Item 1
22 Winbourne Street, West Ryde - LDA2022/0013
Demolition of structures & associated hardstand areas & tree removal

**City of Ryde
Local Planning Panel Report**

DA Number	LDA2022/0013
Site Address & Ward	22 Winbourne Street, West Ryde Lot 1 DP 1274125 West Ward
Zoning	SP2 Infrastructure (Educational Establishment)
Proposal	Demolition of structures and associated hardstand areas and removal of trees.
Property Owners	Department of Education
Applicant	Department of Education
Report Author	Holly Charalambous, Senior Town Planner
Lodgement Date	25 January 2022
No. of Submissions	Nineteen (19) submissions objecting to the development during the first notification period. Two (2) submissions objecting to the development during the second notification period.
Cost of Works	\$4,717,493.00
Reason for Referral to Local Planning Panel	Contentious Development – More than 10 unique submissions objecting to the proposal have been received as a result of public notification of the application.
Recommendation	Approval
Attachments	1. Proposed plans 2. Draft conditions of consent

Figure 7: Extract of the Tree Removal Plan with mark ups to identify the trees permitted to be removed as recommended by Council's Consultant Landscape Architect/Arborist.

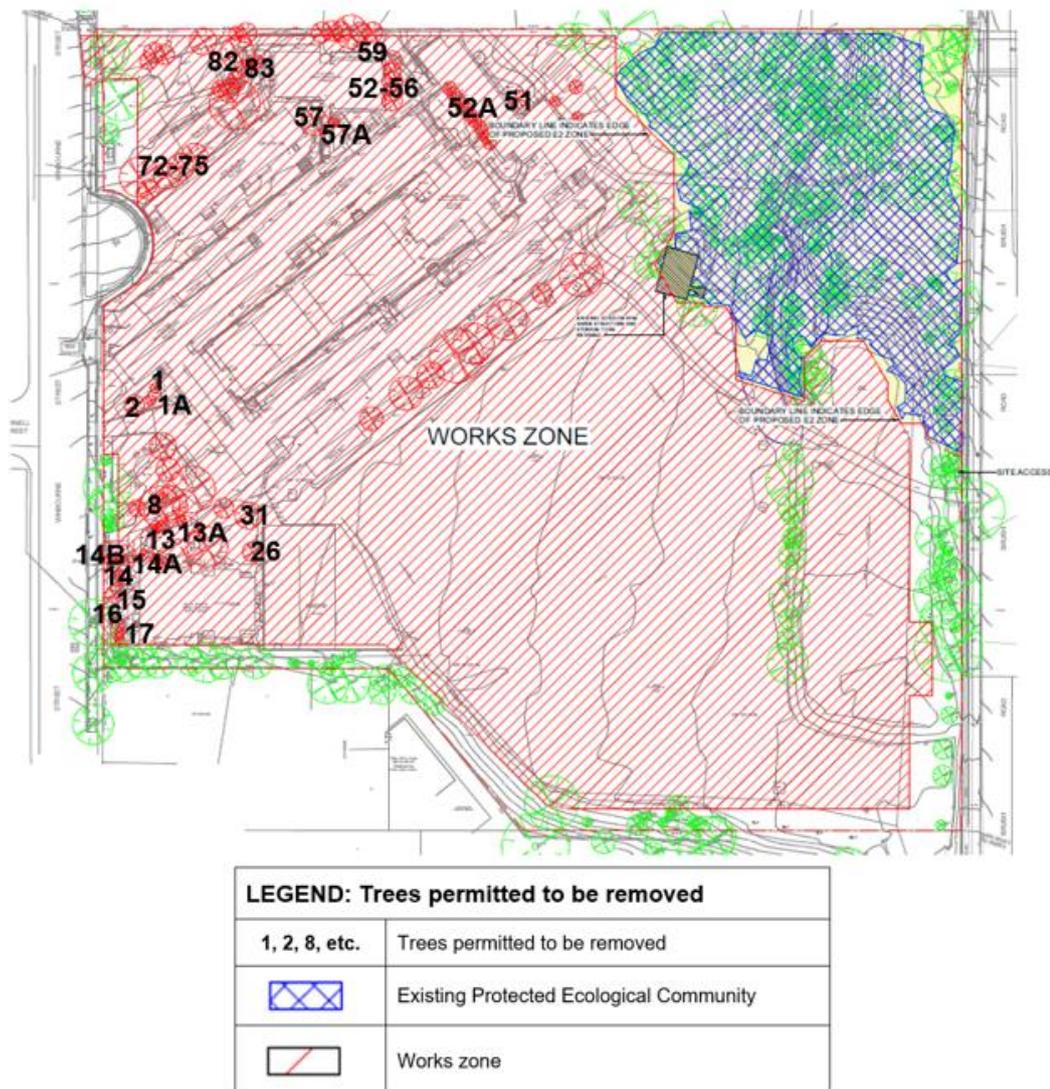
The proposal seeks the removal of 77 trees/groups of trees on the site as shown in **Figure 5** above. Council's Consultant Landscape Architect/Arborist has undertaken an independent desktop assessment and advises that 37 of the 77 trees sought to be removed are capable of being retained throughout the course of demolition works. As discussed in detail in the Internal referral section below, this application supports the removal of only 30 trees/groups of trees, as shown in **Figure 7** below.

Figure 14: Extract of the Tree Removal Plan with mark ups to identify the trees permitted to be removed as recommended by Council's Consultant Landscape Architect/Arborist.

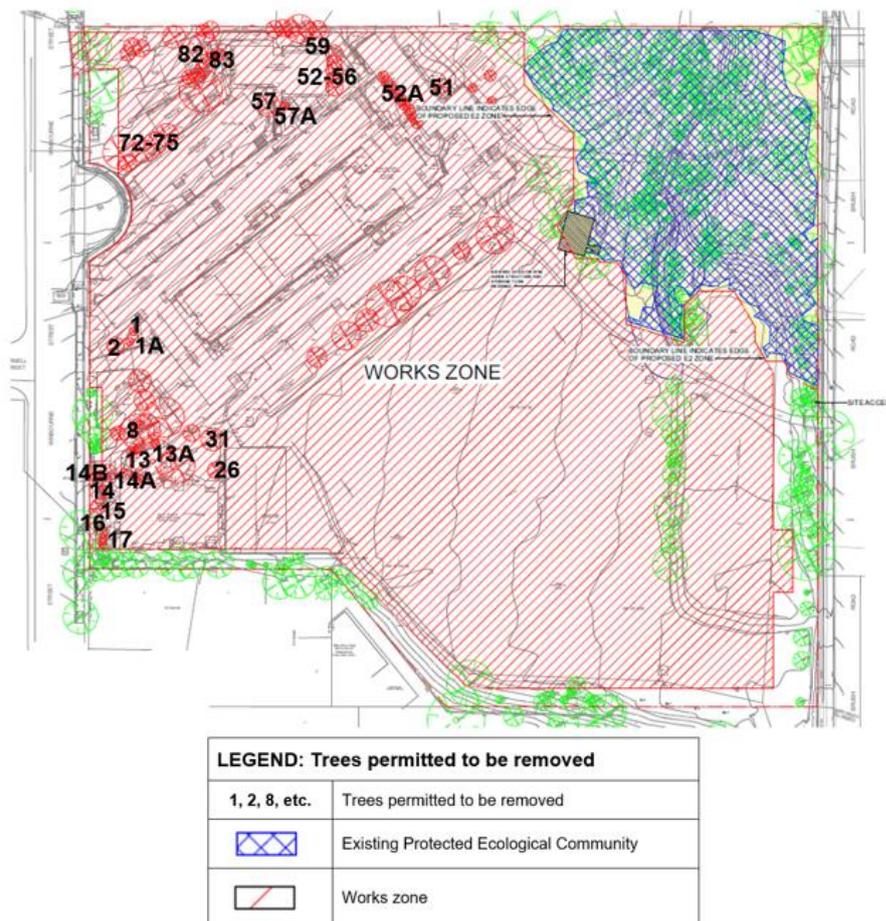
Note: The applicant's revised AIA Report assessed trees to be removed based in calculating the 'Impact area including buffer' as trees within 5m of buildings and within 2m of hard stand surfaces to be demolished. This method is not considered to be a reasonable nor realistic approach to determining impacts to trees on development sites. This methodology is heavily weighted toward tree removal and its use is primarily responsible for the discrepancies between the recommendations of the AIA Report and our independent desktop-based assessment.

Trees to be retained and protected: 88 trees and groups of trees (Trees 3, 4, 5, 6, 7, 7A, 9, 10, 11, 11A, 11B, 12, 16A, 16B, 18, 18A, 19, 20, 21, 22, 23, 24, 25, 25A, 25B, 25C, 25D, 25E, 25F, 25G, 27, 28, 32, 33, 34, 35, 36, 37, 38, 39, 40, 41, 42, 43, 44, 45, 46, 47, 49, 51A (group), 51B (group), 51C, 56A, 56B, 58, 58A, 60, 61, 62, 63, 64, 64A, 65, 66, 67, 68, 69, 70, 70A, 71, 76, 77, 78, 79, 80, 81, 801, 802, 803, 804, 805, 860, 864, 864A, 864B, 864C, 864D and 865) located within the subject site, neighbouring properties and adjoining street verge must be retained and protected in accordance with tree protection conditions.

These recommendations are addressed in **Conditions 10-12, 21, 22 and 48-51**. The trees permitted to be removed are shown in **Figure 14** below.

Drawing Title **TREE REMOVAL PLAN**

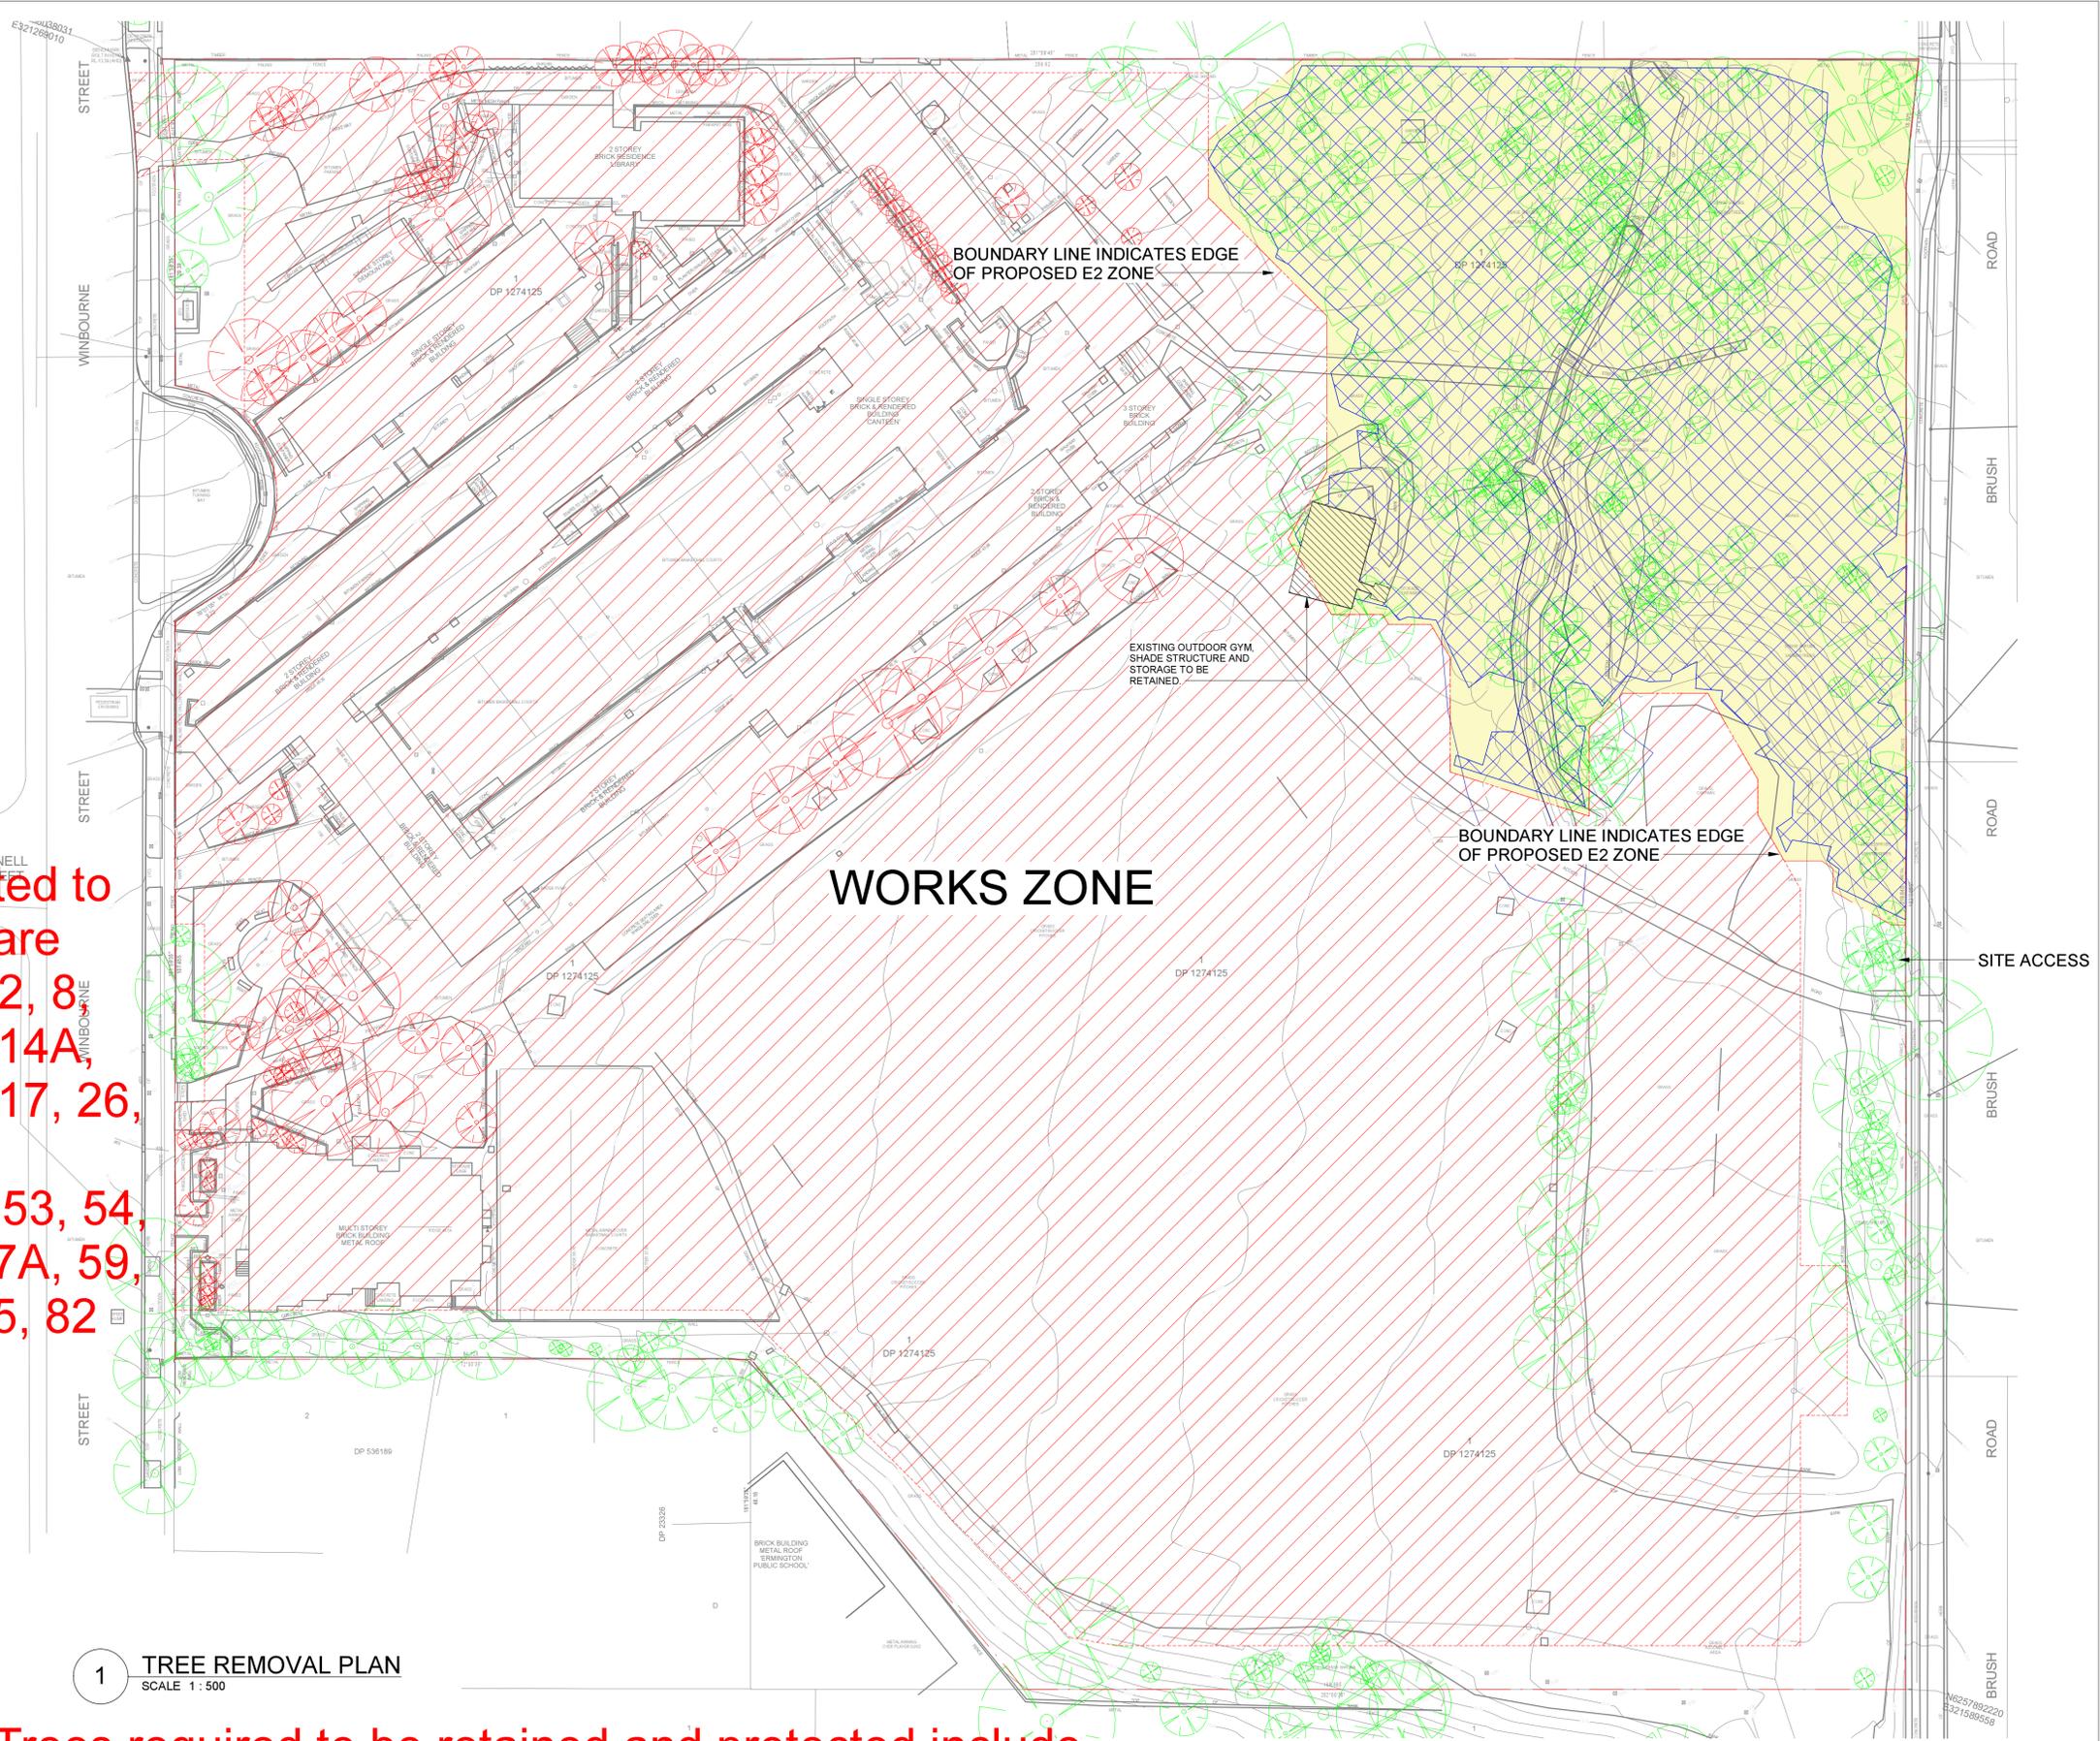
Trees permitted to be removed are
 Trees 1, 1A, 2, 8, 13, 13A, 14, 14A, 14B, 15, 16, 17, 26, 31, 51, 52, 52A (group), 53, 54, 55, 56, 57, 57A, 59, 72, 73, 74, 75, 82 and 83.

Trees required to be retained and protected include
 Trees 3, 4, 5, 6, 7, 7A, 12, 27, 28, 32, 33, 34, 35, 36, 37, 38, 39, 40, 58, 58A, 60, 61, 62, 63, 64, 64A, 65, 66, 67, 68, 71, 76, 77, 78, 79, 80 and 81.

- (a) Trees 3, 4, 5, 6, 7, 7A, 9, 10, 11, 11A, 11B, 12, 16A, 16B, 18, 18A, 19, 20, 21, 22, 23, 24, 25, 25A, 25B, 25C, 25D, 25E, 25F, 25G, 27, 28, 32, 33, 34, 35, 36, 37, 38, 39, 40, 41, 42, 43, 44, 45, 46, 47, 49, 51A (group), 51B (group), 51C, 56A, 56B, 58, 58A, 60, 61, 62, 63, 64, 64A, 65, 66, 67, 68, 69, 70, 70A, 71, 76, 77, 78, 79, 80, 81, 801, 802, 803, 804, 805, 860, 864, 864A, 864B, 864C, 864D and 865 as shown on the Tree Removal Plan and Arborist Impact Assessment are required to be retained and protected.
